TYPICAL PLAN

OPTION 1

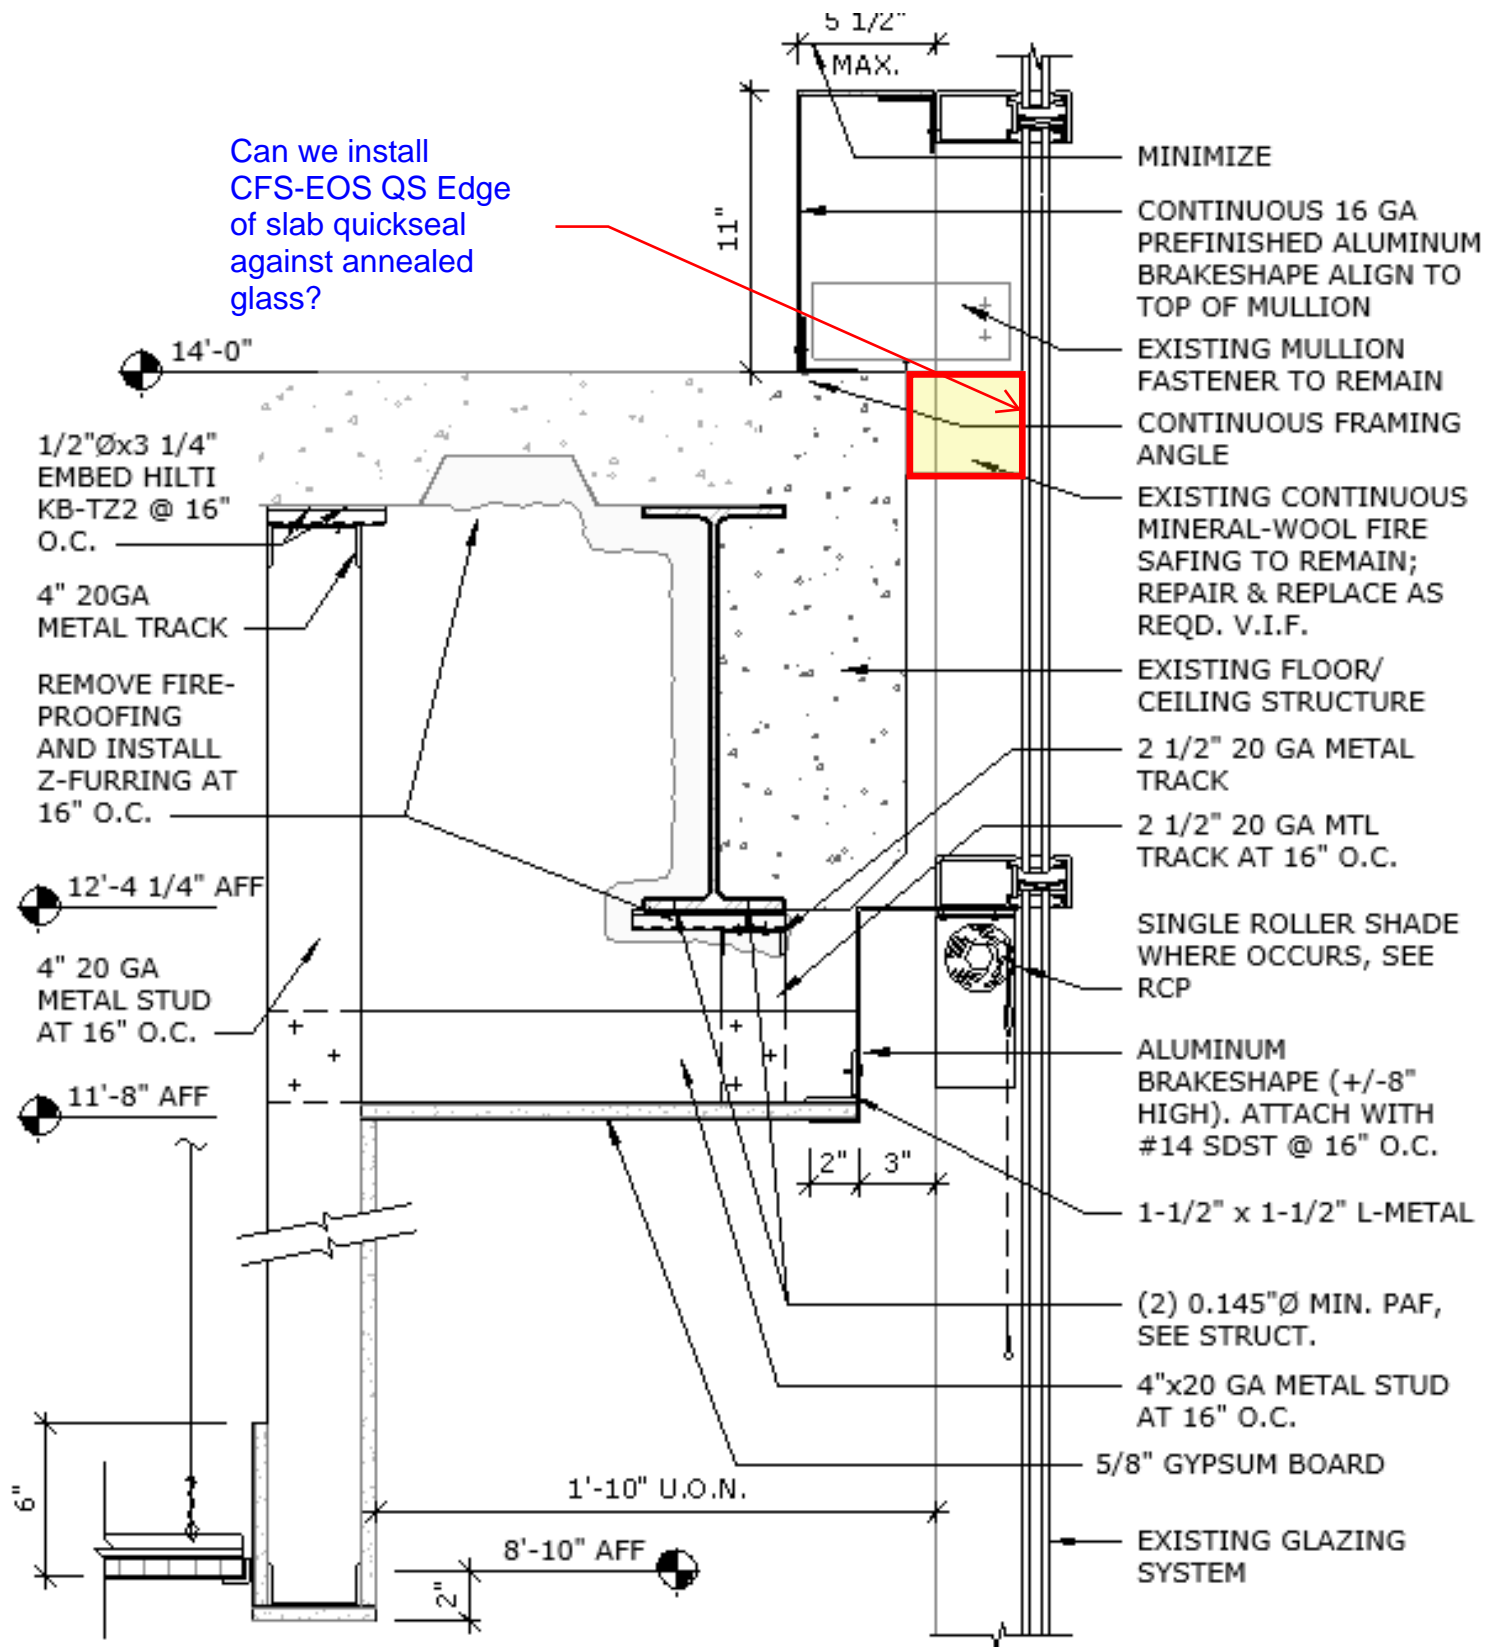
annealed glass and slab are separated by 4"

mullion sits 9" above slab

Glass spans from the 2nd floor to the 7th floor

existing rockwool is falling from floors above.

NOTE: REPAIR ALL EXISTING FIREPROOFING
